Planning Commission Regular Meeting Agenda Wednesday, September 7, 2022 at 7:00 p.m.

Staff Report Site Plan Review Application Mixed-Use Development on North Shore LU 2022 02 (Phase 1) August 31, 2022

Image 1. North Pioneer Street Section as seen in the Downtown Master Plan

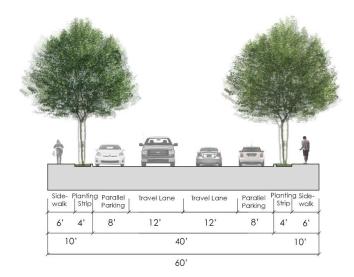
In addressing pedestrian and vehicular safety, the inclusion of urban street improvements along the frontage of North Pioneer Street (image 1), adjacent to the site, will facilitate the movement of pedestrians from the right-of-way, across the sidewalk and to the proposed mixed-use development. The inclusion of on-street parking adjacent to the site will free up off-street parking spaces designated for residents and employees of the mixed-use development. Additionally, on-street parking is a central theme of the Lowell Downtown Master Plan that creates active streets and encourages the built form to interact with pedestrians. Further, on-street parking encourages other by-passing vehicles to reduce driving speed because drivers are wary of traffic and adjacent users.

<u>Staff Response</u>: The applicant will be responsible for the required improvements for proper access, functionality, and pedestrian and vehicular safety of the site. These improvements include, but are not limited to, adequate drainage of the site, including a pedestrian sidewalk entrance from North Shore Drive to the ground floor of the proposed commercial uses, addressing drainage beneath the bioswale that exists between the curb and property line, landscaping and sidewalk, curb and gutter along North Pioneer Street, consistent with the Downtown Master Plan, and landscaping along North Shore for the portion that fronts Phase 1. The City is requiring the improvements, as seen in Image 1, below, for the following reasons:

Condition of Approval #1: Applicant shall submit plans for review and approval by the City Administrator or their designee for the construction of urban street improvements along the frontage of North Pioneer Street, consistent with the Lowell Downtown Master Plan to include a 6' sidewalk, 4' planting strip, 8' parallel parking stall, and street trees to facilitate the movement of pedestrians from North Shore to Phase 1 of the proposed development. The plans shall be approved, before the issuance of building permits.

AS-003

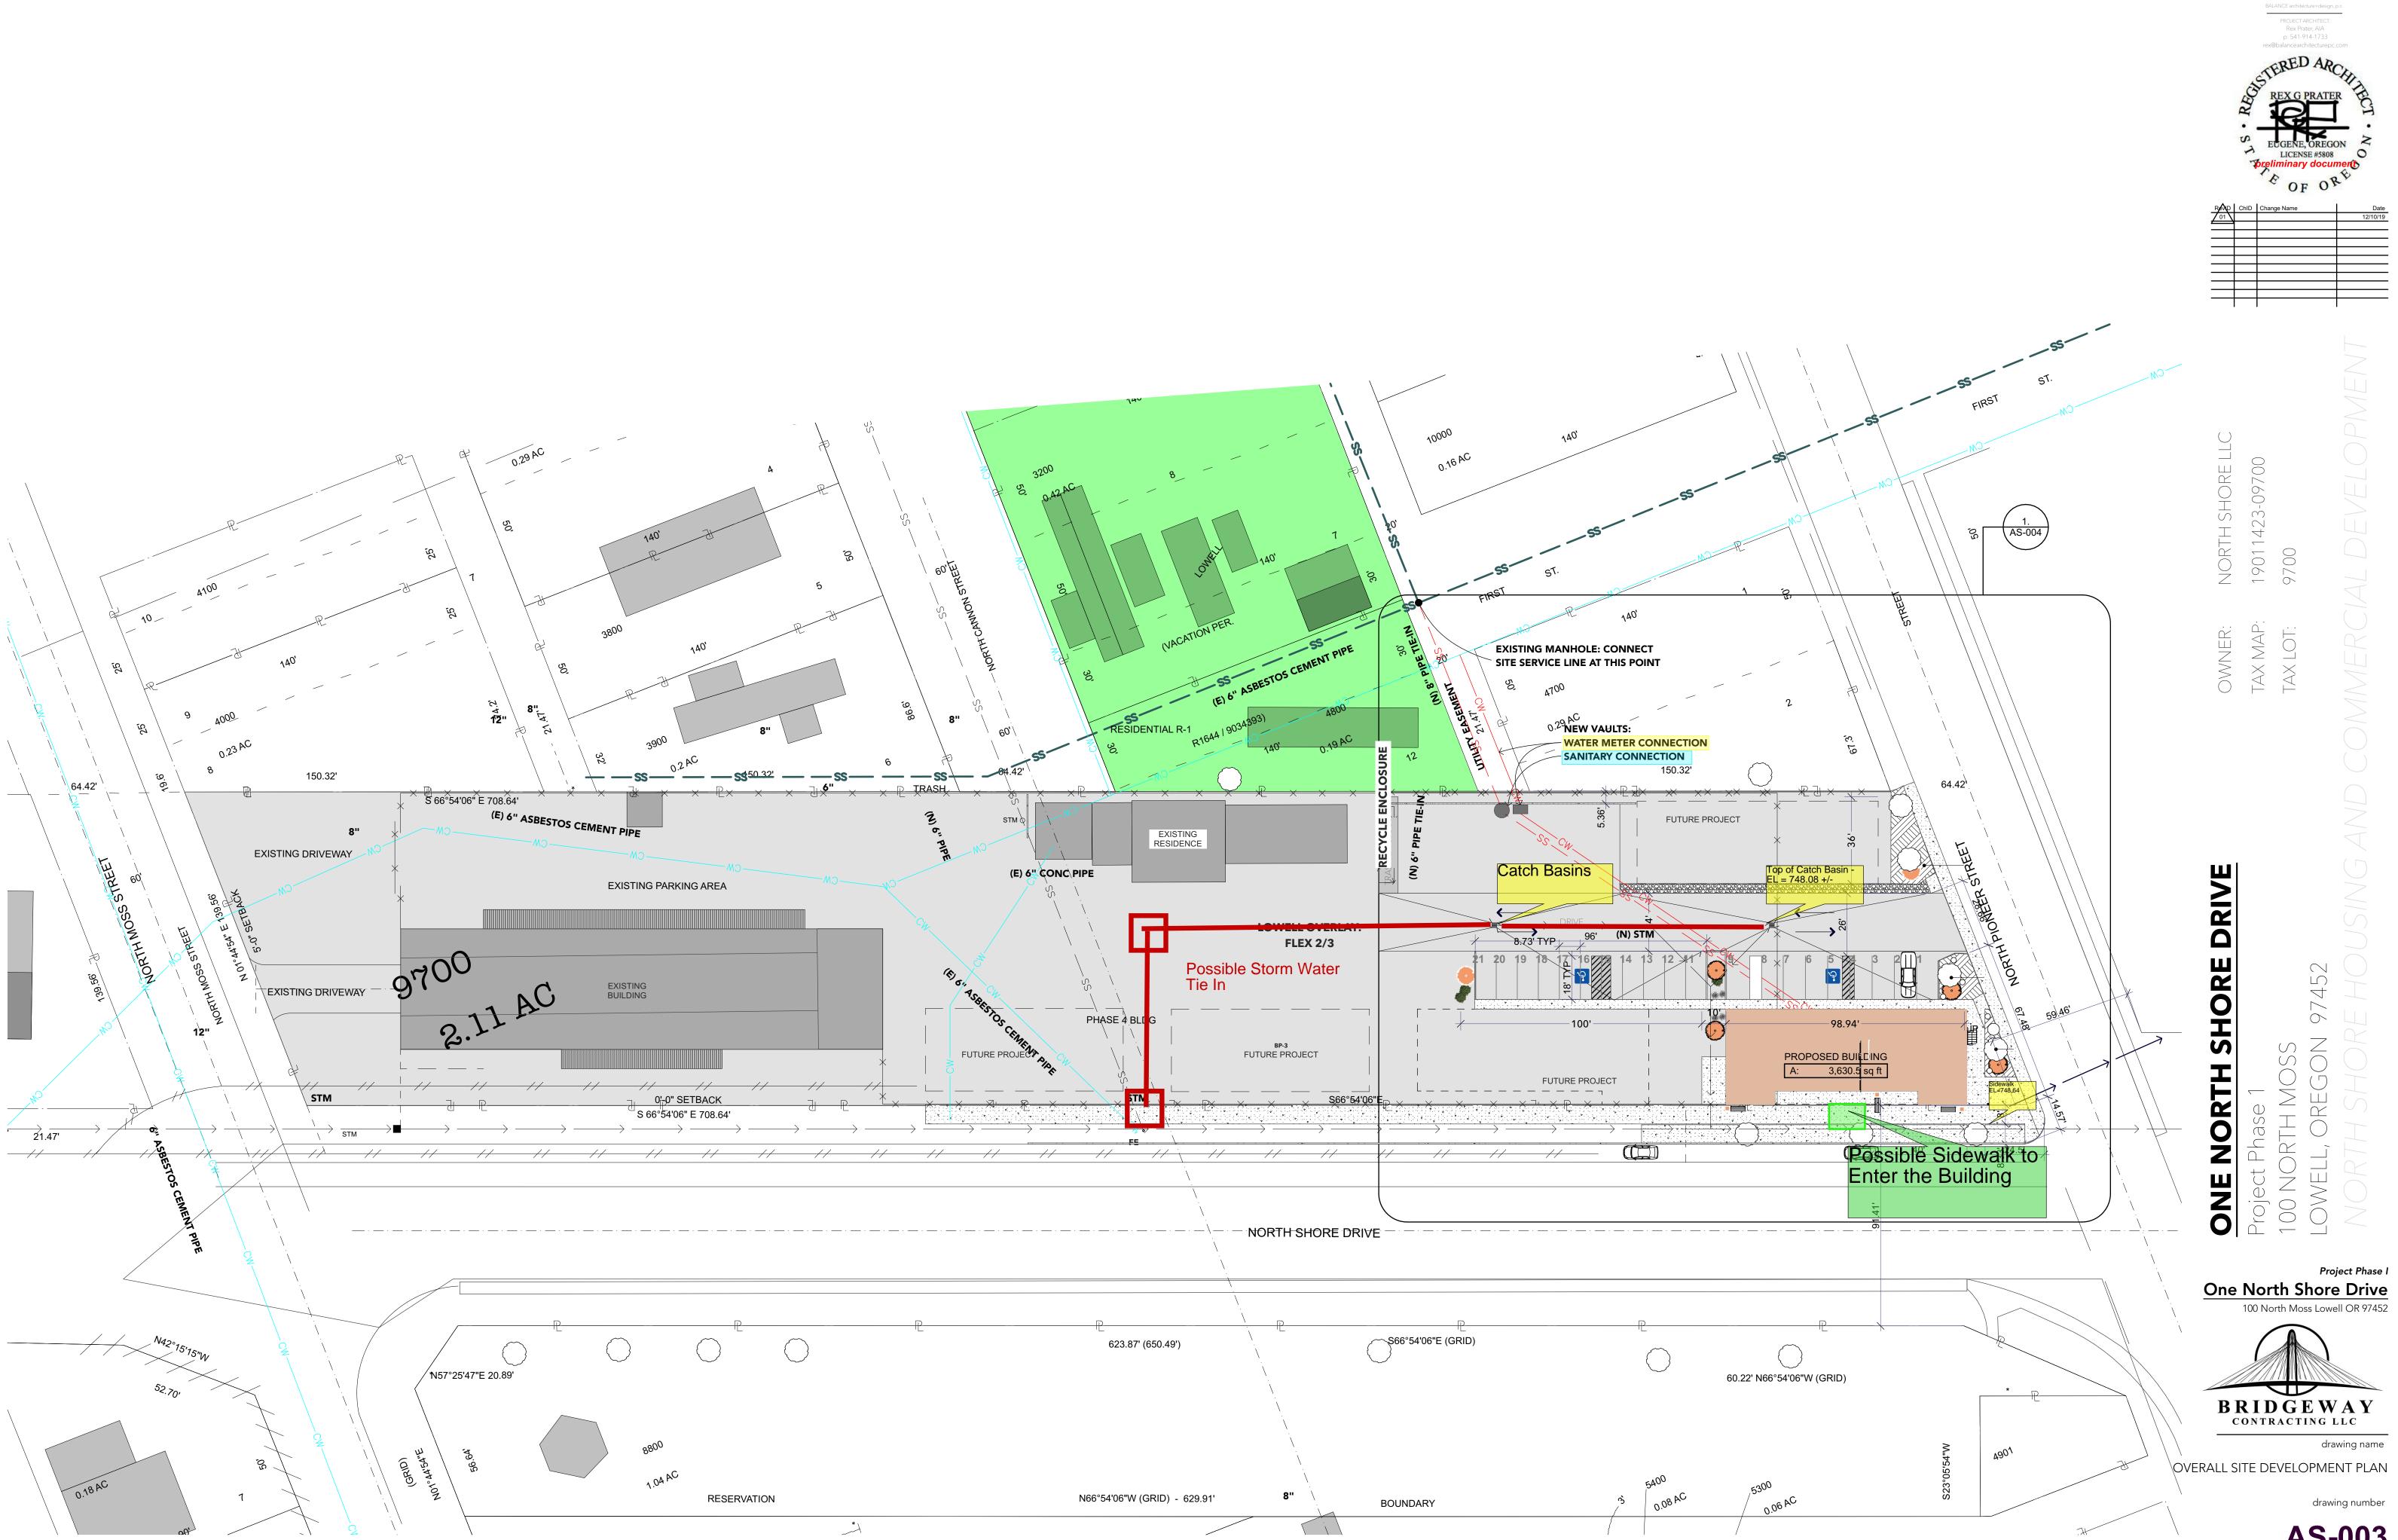
- Landscape plan
 - O There appear to be two site plans in the record submitted by the applicant. Both site plans are labeled "AS-003," but contains different dates. One site plan is dated 7/27/2022 and the other 11/23/2021. Staff are unsure what site plan is the operating and effective site plan.

- Staff are unsure of the landscape improvements are proposed along the frontage of North Shore Drive. Sheet AS-003 shows three tree figures spaced apart, but staff are unsure how this correlate to Sheet L-2.

- The applicant submitted two site plans (labeled AS-003 and dated 11/23/2021 and 7/27/2022) that show top elevations of the catch basins, a stormwater line, elevation of the southeastern sidewalk and a 12" PVC.

Sheet AS-003 does not contain any technical grading or drainage

<u>Staff Response</u>: Street trees will be required. As seen on Sheet AS-003, evergreen tree plantings are shown in the planter areas. Staff will include an informational item that street trees shall be placed a minimum of 10-feet from fire hydrants and 20-feet from stop signs. Sheet L-2 shows under Version A includes a canopy tree that is 30 linear feet. Street trees are only required along the frontage of North Shore Drive for the length of Phase 1 and the frontage of the site along North Pioneer Street. The proposal meets this policy.

Staff Response: As seen on Sheet AS-003, the entrances along the frontage of North Shore Drive will have covered entries. The proposal is consistent with this policy.

Staff Response: As seen on Sheet AS-003, the parking lot contains one curbed landscape island between parking stall # 9 and #11. The landscape island appears to contain a tree feature. The code standard is for trees to be placed at the ends of parking rows to facilitate movement of traffic and to break large areas of parking surface. The proposal is short one landscape island, with a tree, at the end of the parking spaces. A landscape island, with a tree, will need to be placed at the end of the proposed parking spaces for Phase 1. This will be a condition of approval.

Staff Response: As seen on Sheet AS-003, the applicant is proposing a recycling enclosure at the far western side of Phase 1 see "recycle enclosure" on site plan. The plans do not show how the recycling enclosure will be screened from public view and landscaped. This will be a condition of approval.

• Sheet AS-003 indicates there is an existing residence located along the rear property line. What is to become of this residence? And it is really a residence? This residence has no address assigned to it.
